**GT 4.3inch, Command Input Type**

GT 7inch, Video Input Type / DVI

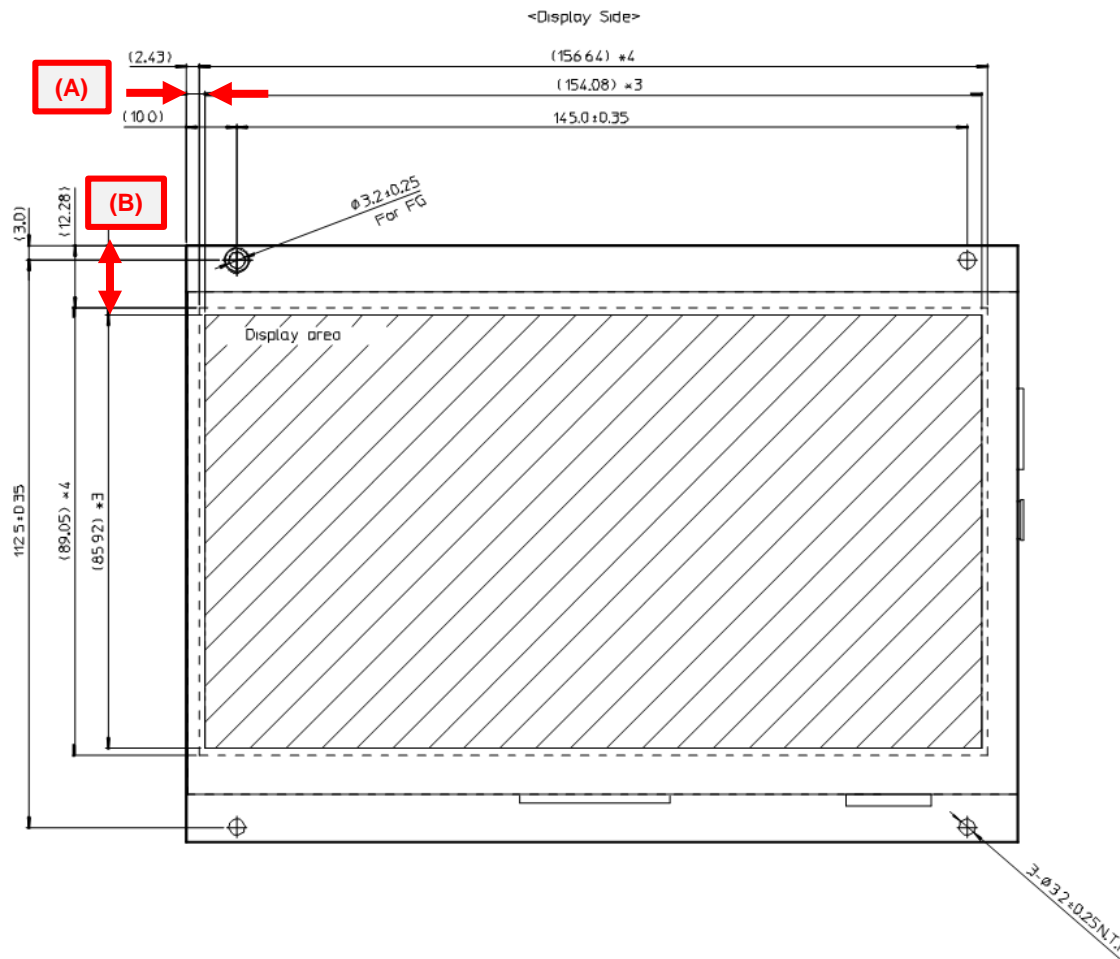
Content	Current GT480X272A-C903PA	New (Change LCM) GTWQ043C3A00PA	Difference
Not difference in specification	—	—	—

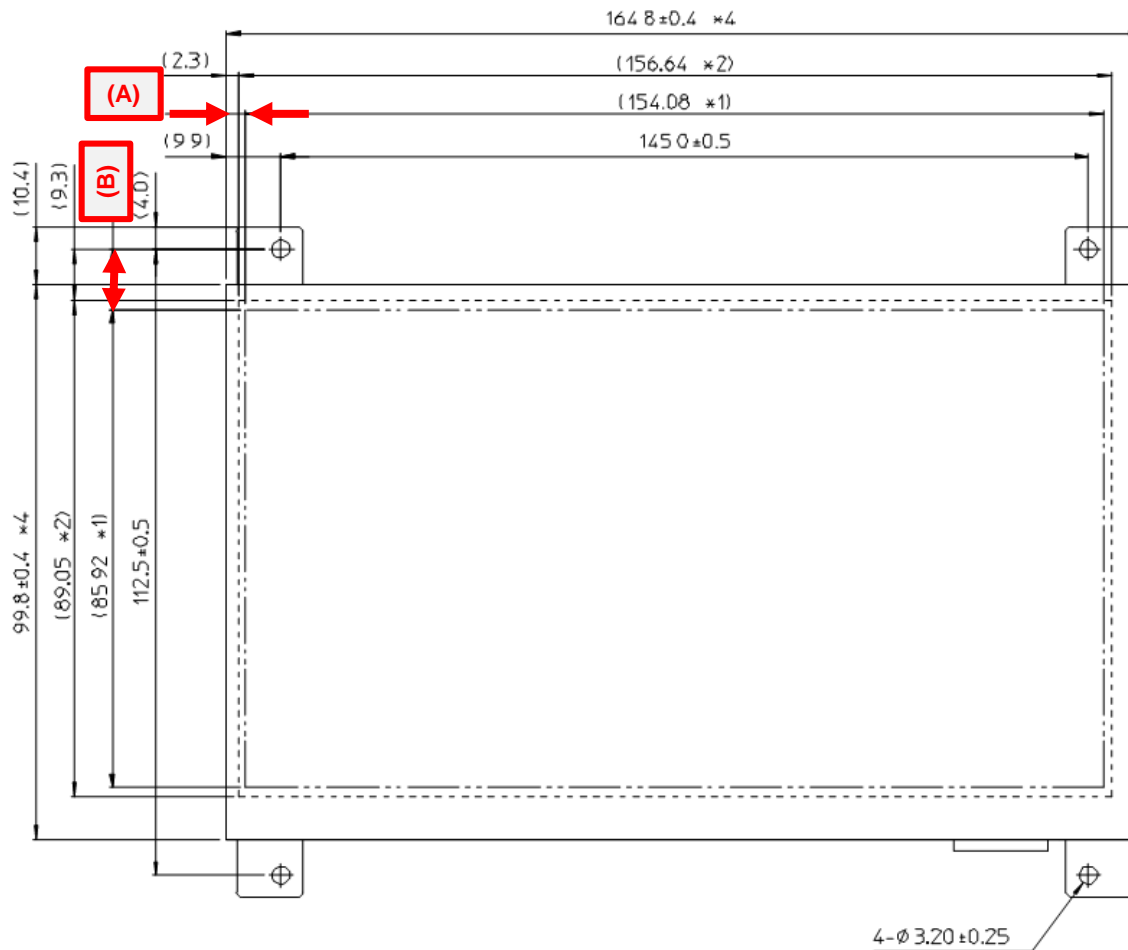
Content		Obsolete GT800X480A-1303P	Successor GTWV070VHA00P	Difference
LCD AA Position	(A) X	(3.71)	(3.95)	+0.24
	(B) Y	(13.84)	(13.99)	+0.15

Content		Obsolete GT800X480A-1013P	Successor GTWV070VRB00P	Difference
LCD AA Position	(A) X	Spec. Value (3.6)	(3.85)	+0.24
	(B) Y	Spec. Value (10.8)	(11.04)	+0.15

Content		Obsolete GT800X480A-C903PA	Successor GTWV070C3A00PA	Difference
LCD AA Position	(A) X	(3.71)	(3.95)	+0.24
	(B) Y	(13.84)	(13.99)	+0.15
